HANS WITTLER'S AUTO
ADDITION & REMODEL
121 ELIZABETH ST NE
ALBUQUERQUE, NM 87123

C1.1

PROJECT: WITTLER AUTO IMPROVEMENTS
GRADING AND DRAINAGE PLAN
&
HYDROLOGIC ANALYSIS

PROJECT NO. 2013.102
DRAWN KC
CHECKED JC
DATE 08-28-13
SHEET C1

GRADING & DRAINAGE PLAN

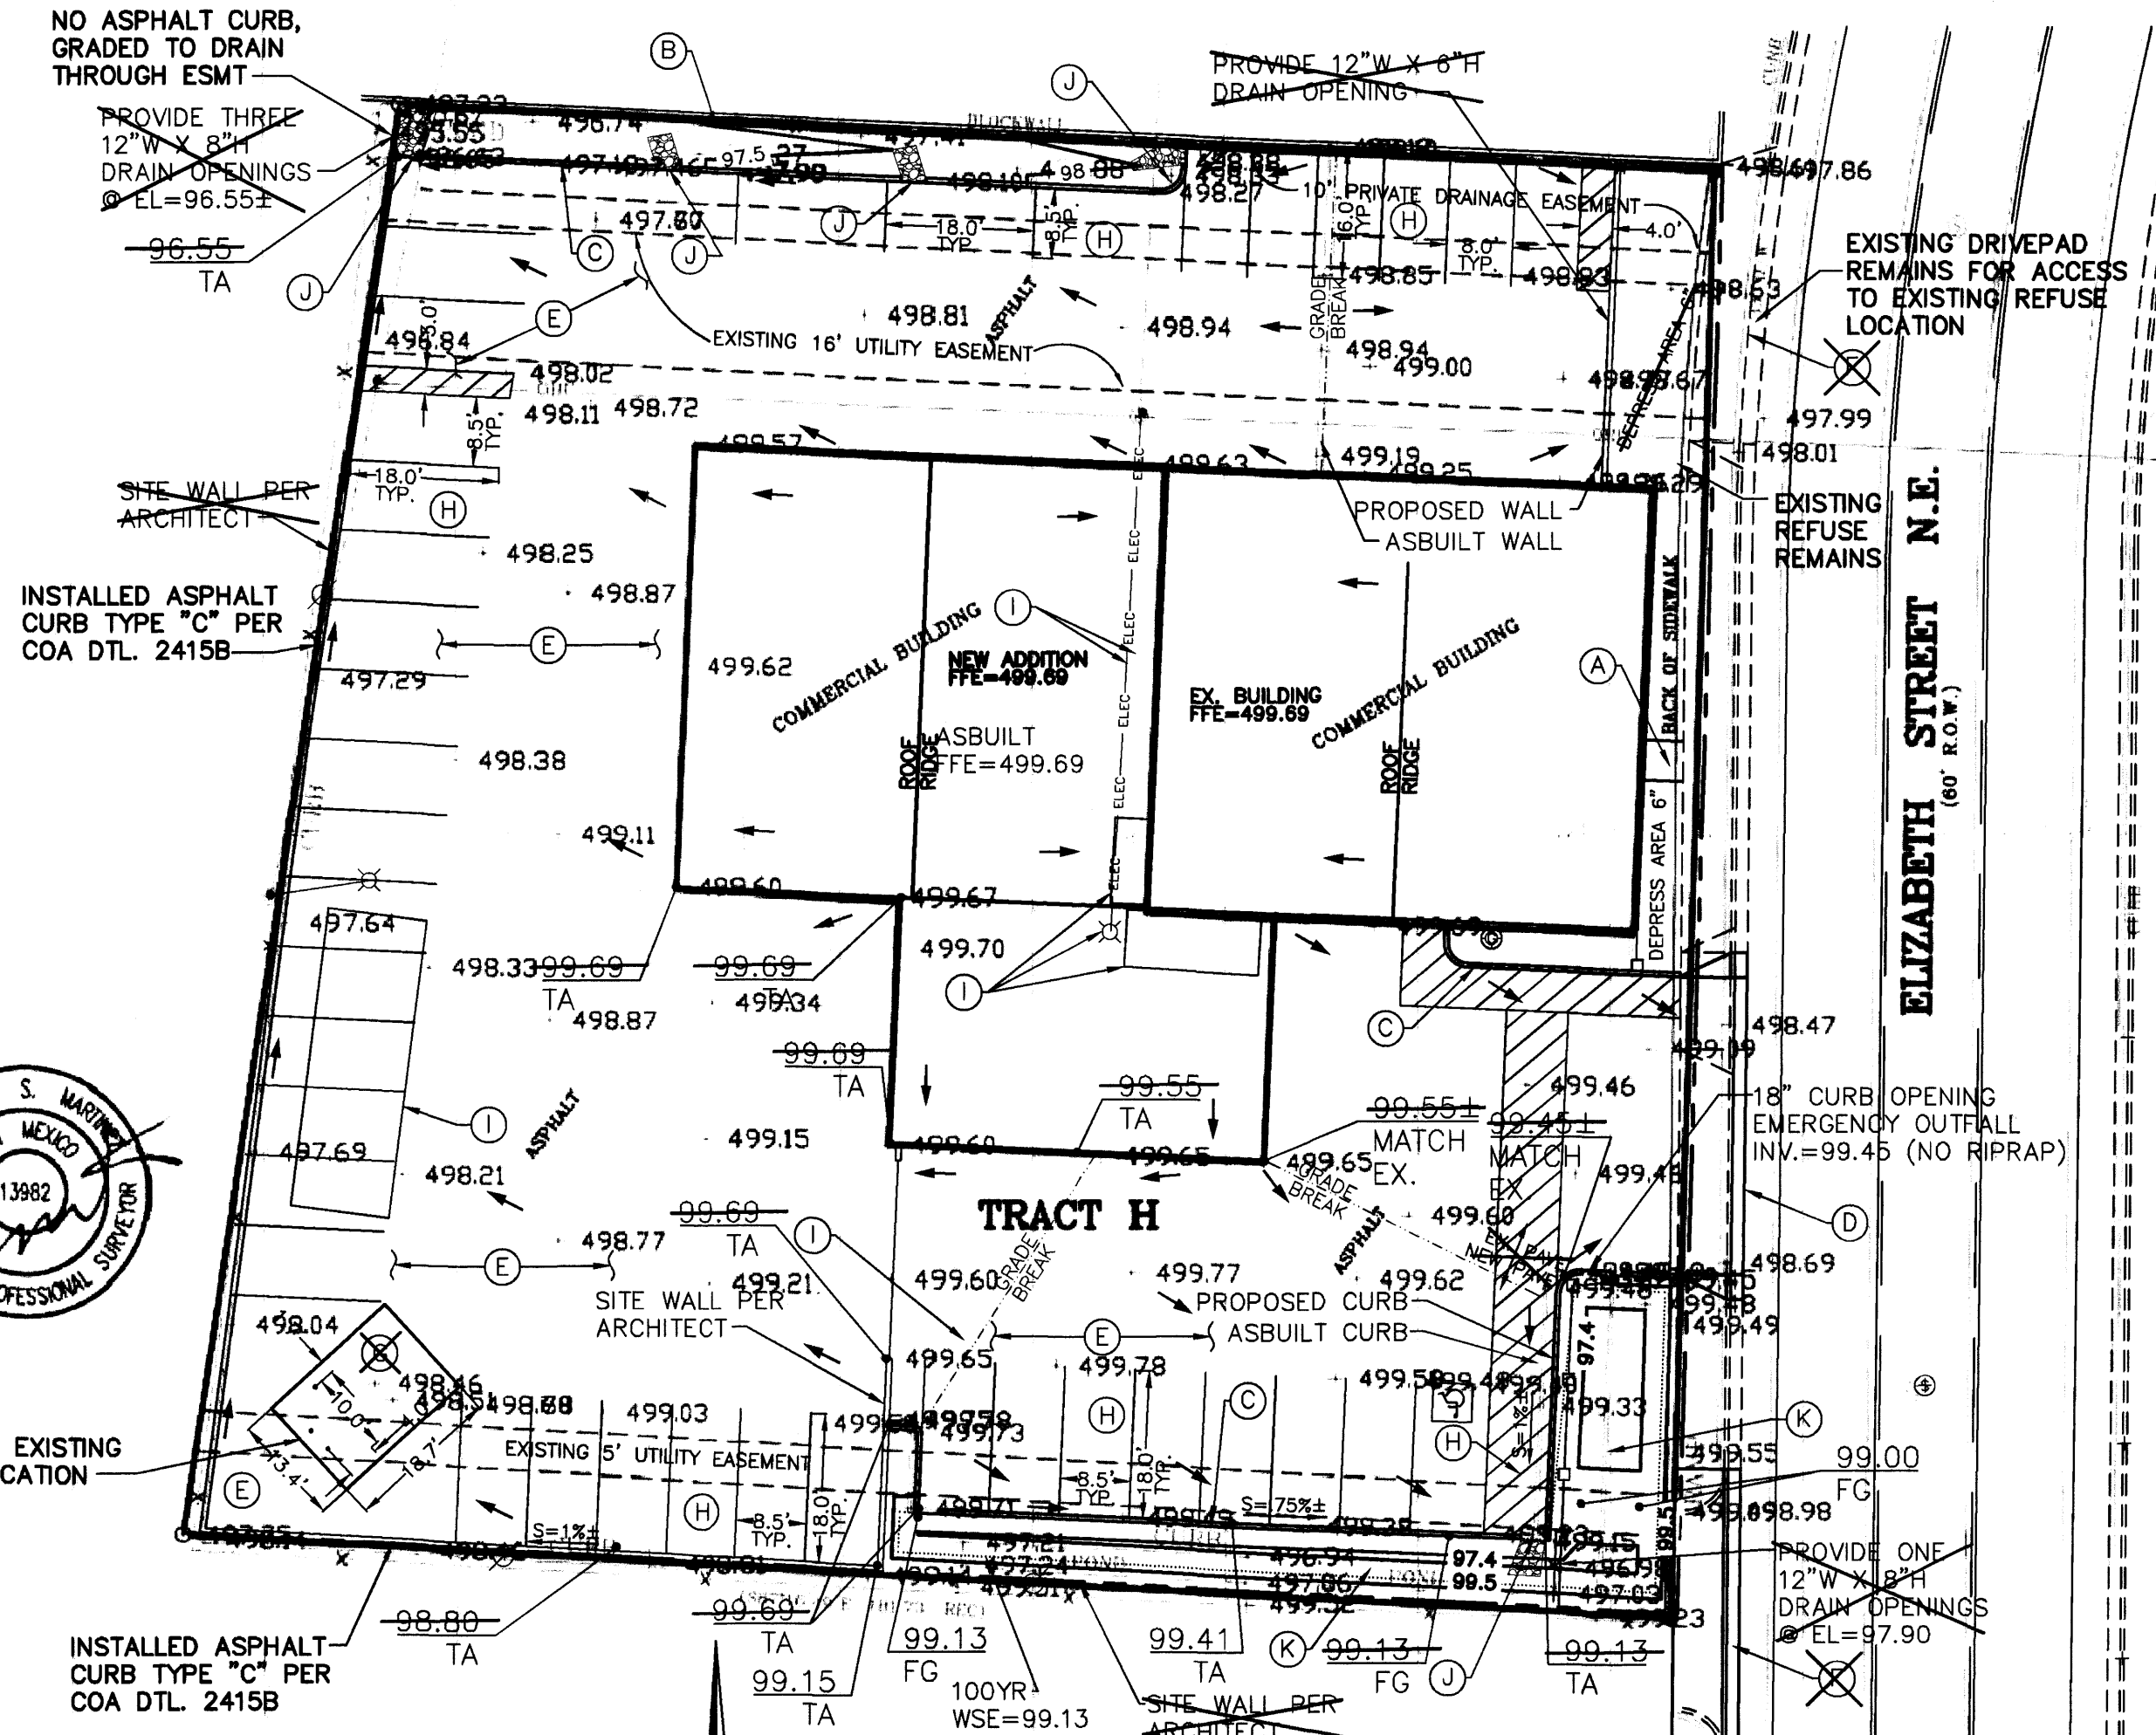
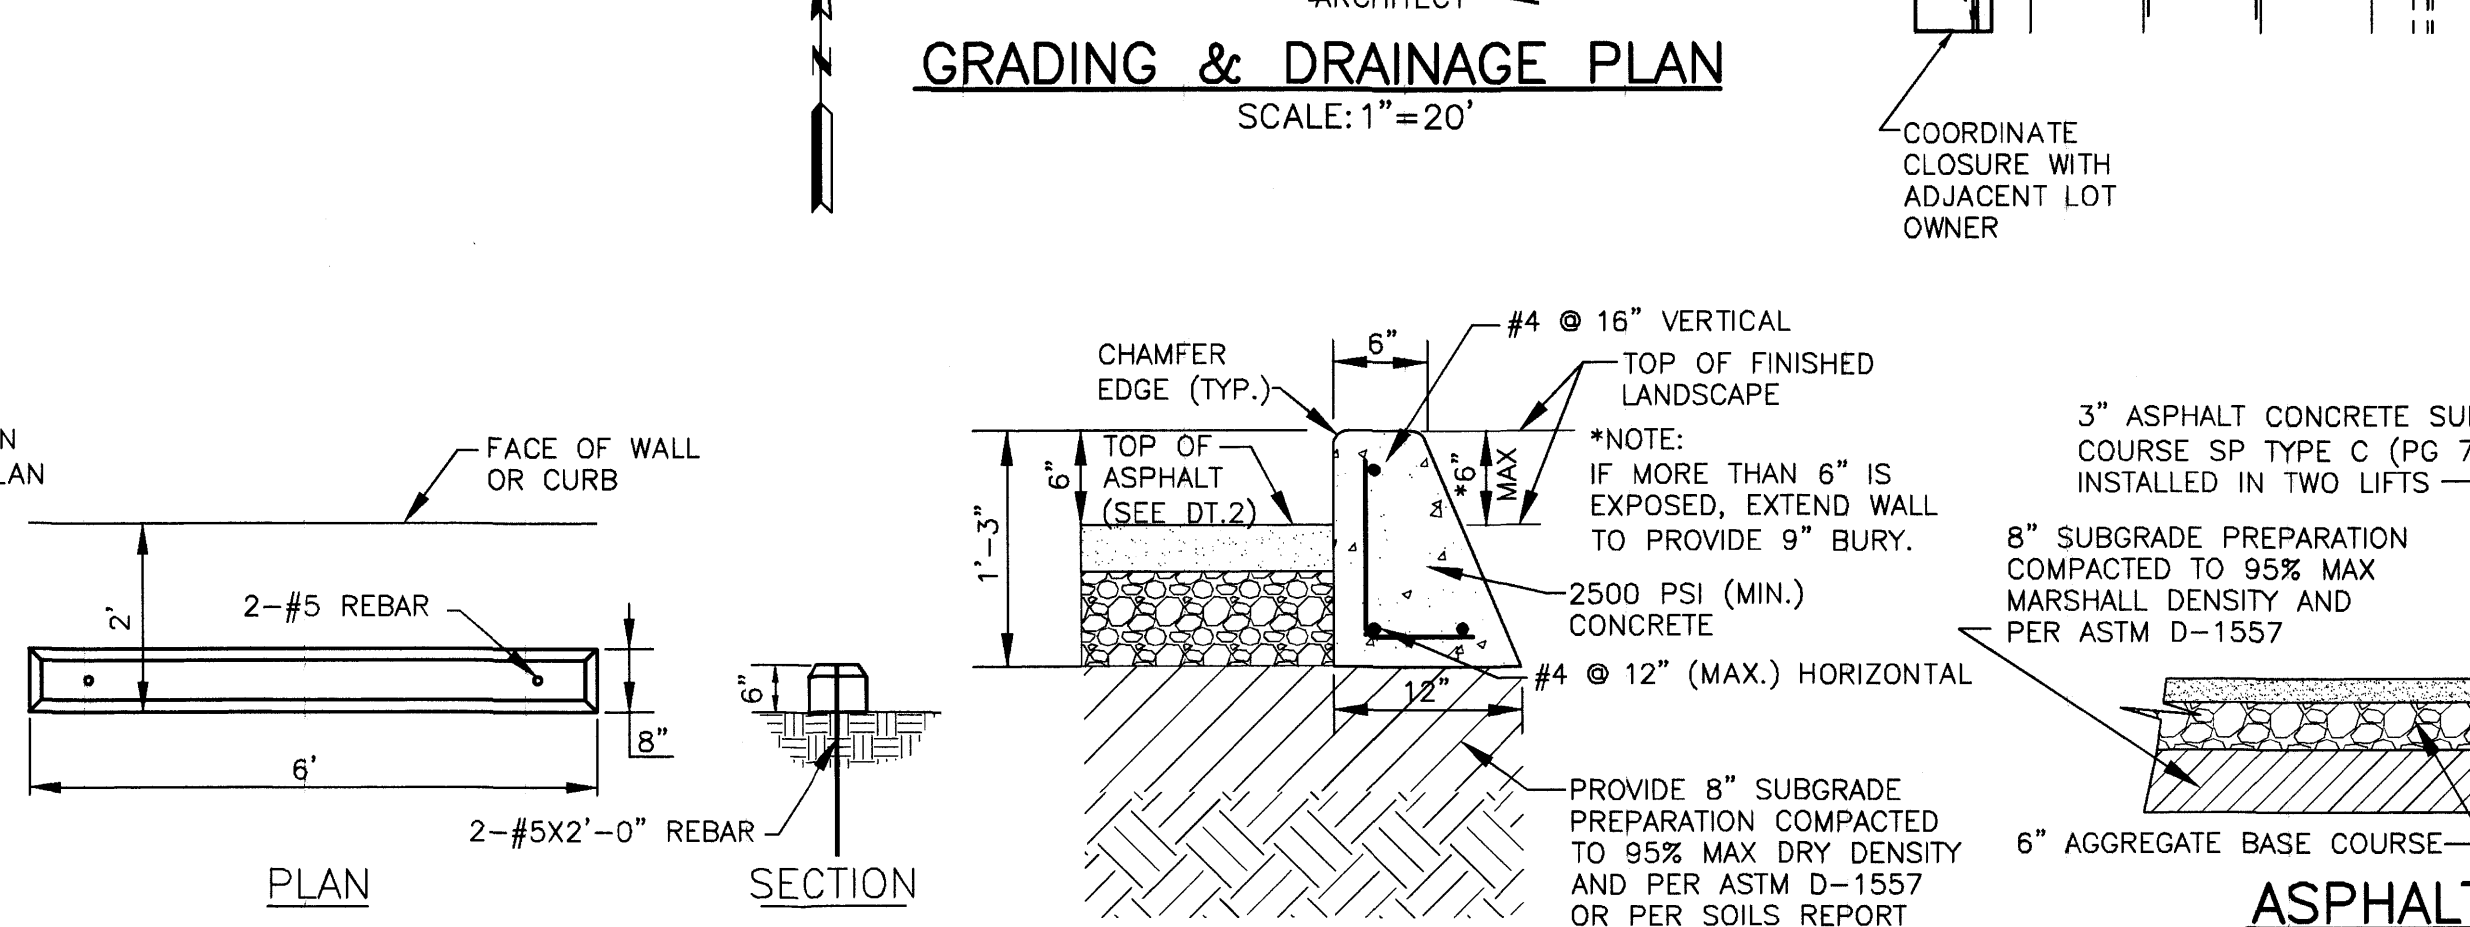
DRAINAGE AREA "A" 6.8%
395 760 sf = 7.9% PERV. (B)
5,447 8,730 sf = 92.1% IMPERV.
ANALYSIS RESULTS 93.2%
0.70 Q = 1.05 cfs
1,327 V = 2,142 cf

580 566 sf = 3.6% PERV. (B)
18,475 16,271 sf = 96.4% IMPERV.
ANALYSIS RESULTS 97%
2.16 Q = 1.80 cfs
4,445 V = 3,687 cf

1,260 1,188 sf = 25.2% PERV. (B)
3,787 3,469 sf = 94.6% IMPERV.
ANALYSIS RESULTS 74.9%
0.51 Q = 0.47 cfs
999 V = 913 cf (RETAINED)

POLYGONAL CHARACTERISTICS: 610 SF
TOP PERIMETER AREA = 654 SF
BOTTOM PERIMETER AREA = 228 SF
DEPTH = 1.70 FT
V = (1/2)(654 SF + 228 SF)(1.7 FT) = 920 CF
643 SF 2.3 FT 1,002 CF
